CITY PLANNING COMMISSION

- APPLICATION:**
- A. Negative Declaration
 - B. Special Permit for deep lot development with an infill density bonus to allow four duplexes on 0.8+ vacant acres in the Single Family (R-1) zone
 - C. Lot Line Adjustment to relocate the common property line between 2 lots on 1.4 partially developed acres

LOCATION: 1044 Sonoma Avenue, 3042 Branch Street

P86-348

SKETCH TO ACCOMPANY
 LOT LINE ADJUSTMENT
 OF A PORTION OF LOTS 1, 2 & 3 OF
 NORTH SACRAMENTO SUBD. NO. 8 (13 B.M. 49)

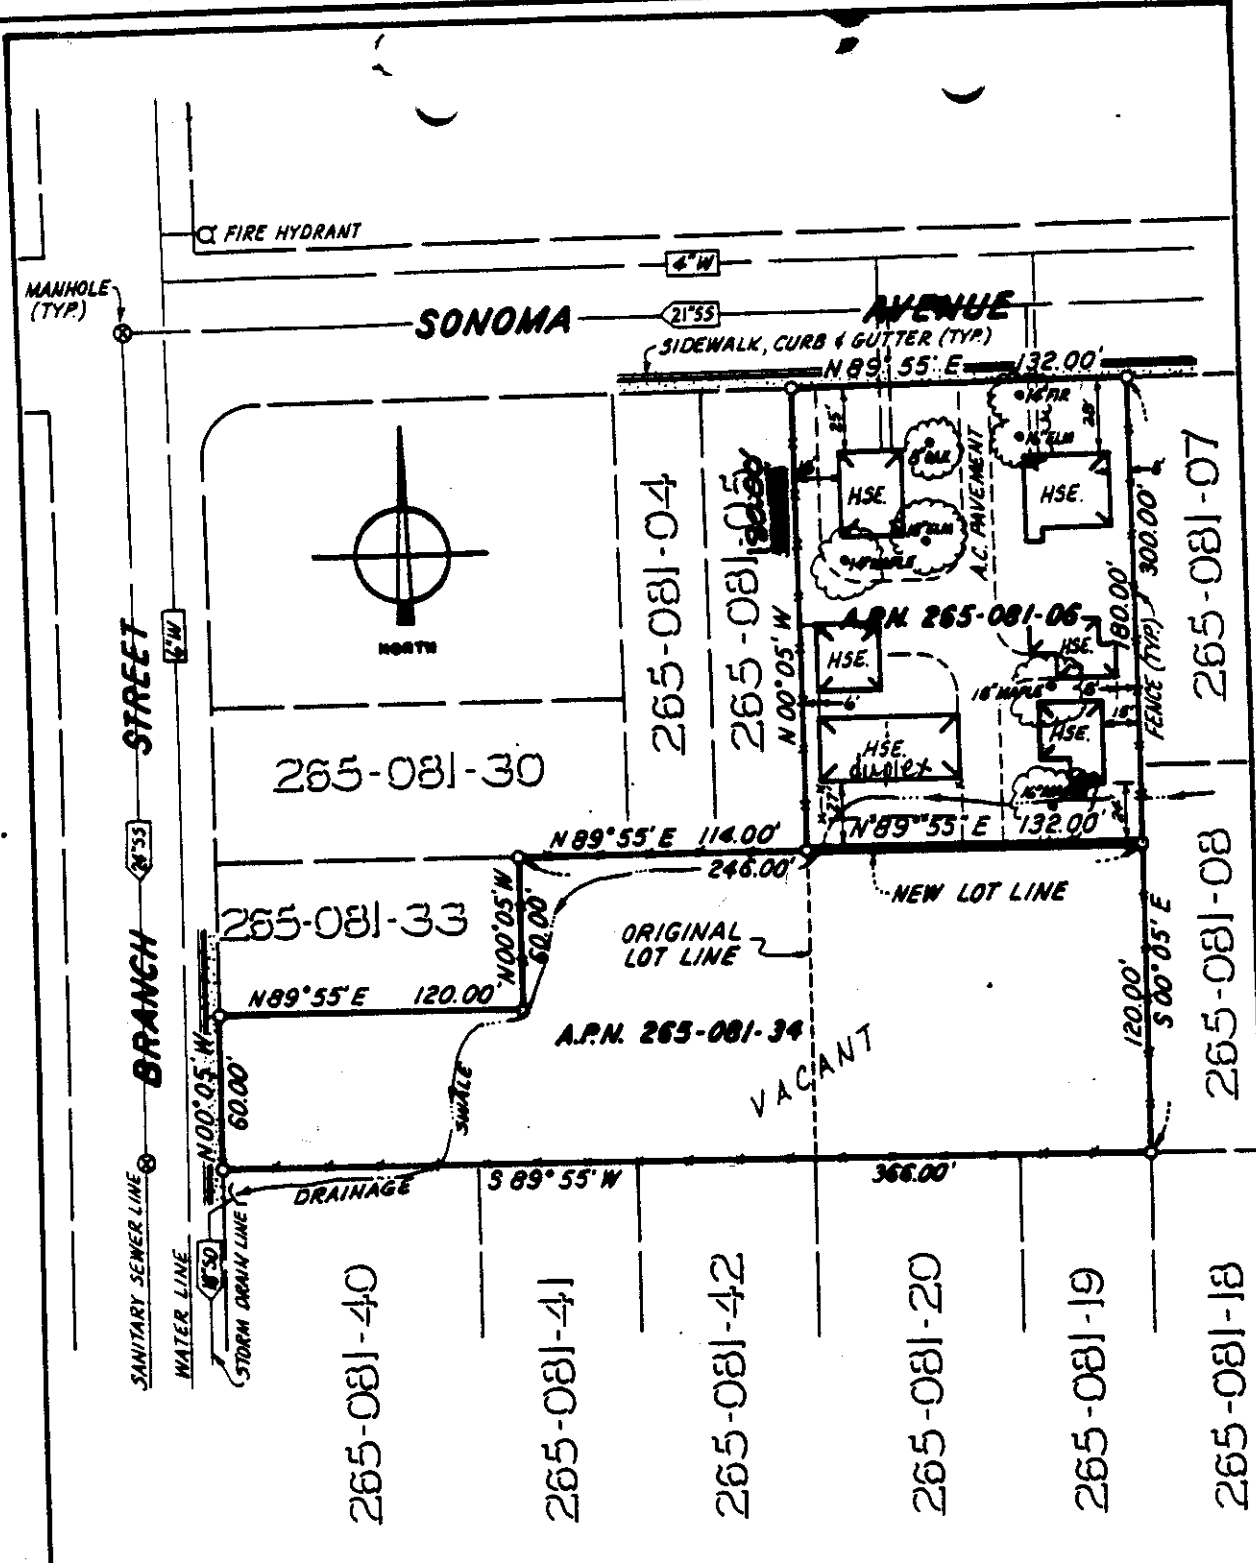
C. Density of Developed Parcel: The proposed lot line adjustment would reduce the lot area of the developed parcel to 23,760 square feet, which would create substandard lot area conditions for the existing seven residential units. There would be only 3,394 square feet of lot area per dwelling unit, rather than the required 5,200 square feet per unit. The total deficit would be 12,640 square feet.

In addition to the substandard lot area per dwelling unit problem, the proposed lot line adjustment would create a developed lot which would be inconsistent with the 1984 North Sacramento Community Plan. The Community Plan allows for eight dwelling units per acre in this area, but the lot adjustment would result in a density of 12.8 units per acre on the parcel. Due to these factors, staff does not support the lot line adjustment. At its present size, lot 06 could accommodate one additional dwelling unit. Even if any "extra" square footage beyond the minimum required for the seven existing units were added to the rear of the vacant lot, this would mean only 3200 square feet that would be available. When added to the existing 18,480 square feet of the vacant lot, there would be no additional gain of allowable dwelling units. 18480 divided by 5200 is 3.55 dwelling units, and 21,680 divided by 5200 is 4.17 dwelling units. For the applicant, then, it is better not to do a lot line adjustment. Then one additional unit can be added to the rear of the existing developed parcel and four units (or five with an infill density bonus) could be developed on the currently vacant parcel.

As previously discussed, staff does not support the lot line adjustment. Under the City's deep lot development ordinance, the Planning Commission is authorized to reduce the required lot area per unit with a special permit, if warranted by the shape, size and location of the parcel, or the location of buildings proposed or existing at the time of the application. Staff has found that this standard should not be modified, due to the nature of existing development and the plans for development of the now-vacant parcel 34. It is important that in a single-family area, adequate usable open space be provided and density remain at levels compatible with the surrounding neighborhood. Staff would support approval of a deep lot permit for development of four units on the existing parcel 34. Staff would not support an infill density bonus for this parcel, since its shape and other development criteria would make it very difficult for that lot to accommodate five units and meet City standards.

- A. ratify the Negative Declaration;
- B. deny the Lot Line Adjustment;
- C. approve the Special Permit, subject to conditions and based upon the findings of fact which follow;

SITE PLAN

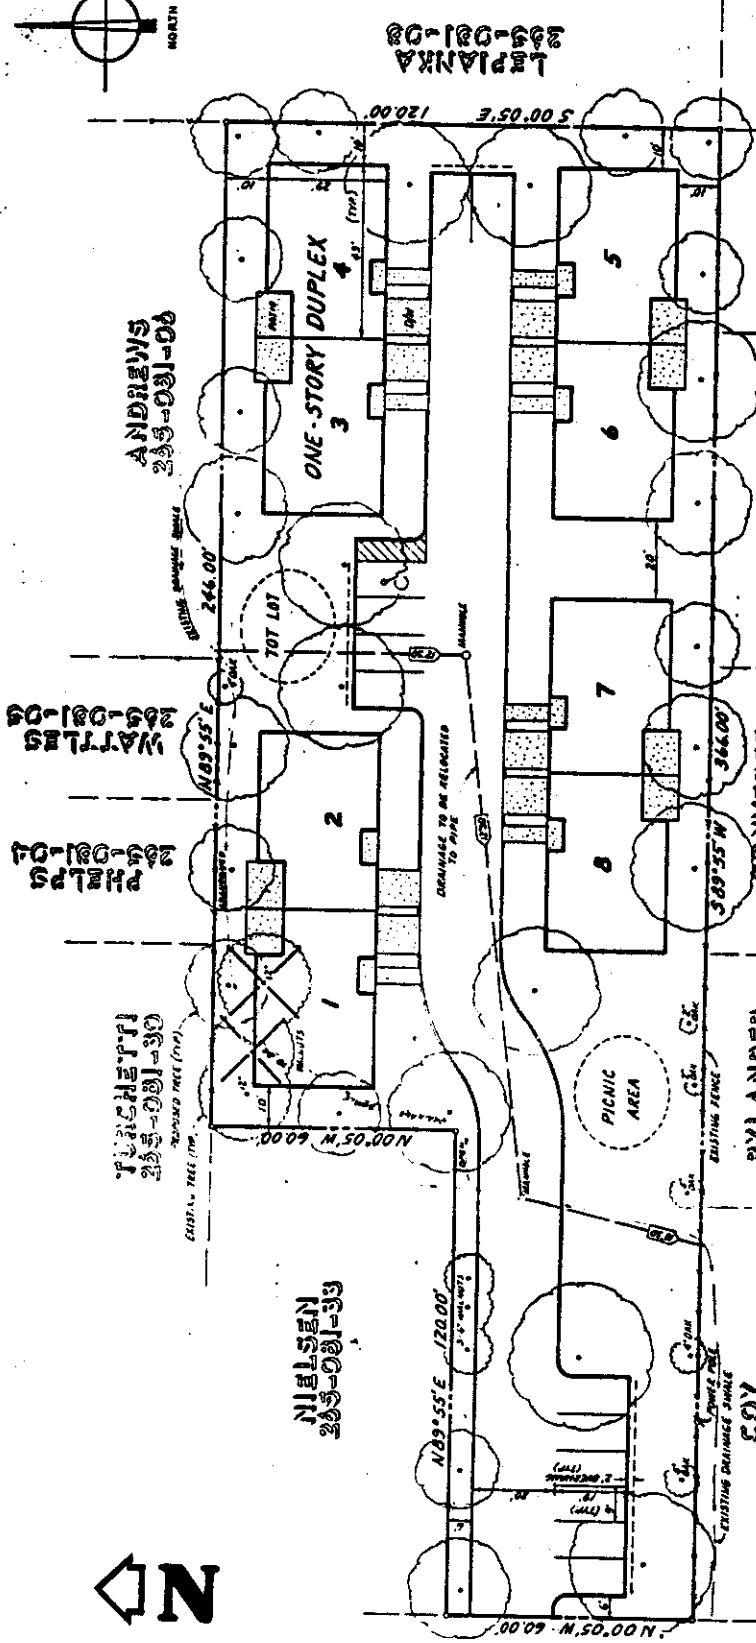
- F. Design of Parcel 34: The proposed project has been reviewed for consistency with the deep lot development guidelines. The size of the units and the inclusion of garages and washer-dryer hookups are positive elements of the design. The street orientation, exterior materials and setbacks do not meet the intent of the guidelines. Regarding street orientation, the front unit should have its entry facing the street rather than a side on orientation. The front unit should either be a single unit or give the appearance of a single family home, in order to be compatible with the character and streetscape of the area. The exterior materials used should complement the surrounding area and set an example for upgrading the area. The setbacks should exceed the minimum five feet wherever possible, especially where the side yard area serves as the functional rear yard of the deep lot units. If private yards or patios are provided, access to these spaces should be directly from the adjoining room.

1. provide 24 foot width for two way driveway
2. provide 26 foot maneuvering width

5. the exterior materials used shall be horizontal wood siding, stucco or wood shingle; not T-111;
6. window trim should be as per attached Exhibit B;
7. Revised site plan and elevations shall be submitted to the Planning Director for review and approval prior to issuance of building permits.

**EXHIBIT A
SITE PLAN
ALTERNATIVE**

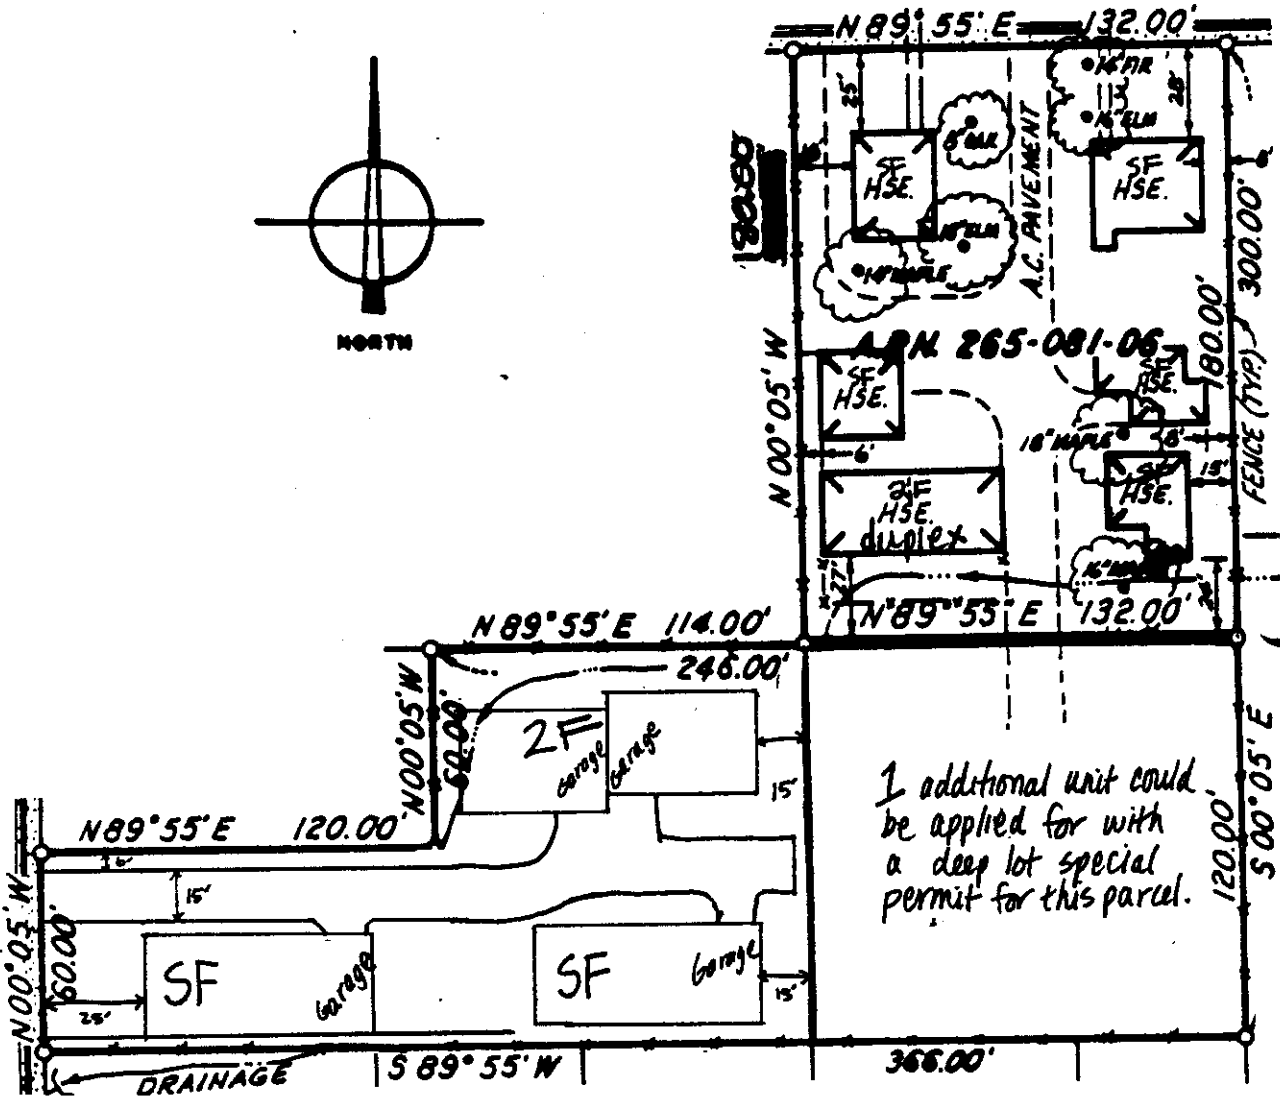
- G. Staff Alternative Site Plan for Parcel 34: Based on a capacity of four dwelling units, which staff feels is the most that can be accommodated on the site while meeting City standards, staff has prepared an alternative schematic site plan for the site. This alternative, along with conditions of approval, is supported by staff and is attached to this report as Exhibit A.

1 additional unit could be applied for with a deep lot special permit for this parcel.

1. the total number of dwelling units permitted on parcel 226-081-34, shall be four as indicated by exhibit A;
2. the single family unit facing Branch Street shall have front door and window orientation to Branch Street and be designed to reflect the traditional single family residential character of the area;
3. the rear single family and duplex units shall be oriented to the driveway, with living areas designed to take advantage of usable open space;
4. the duplex shall be designed to break up the continuous roof line, such as by offsetting the units;
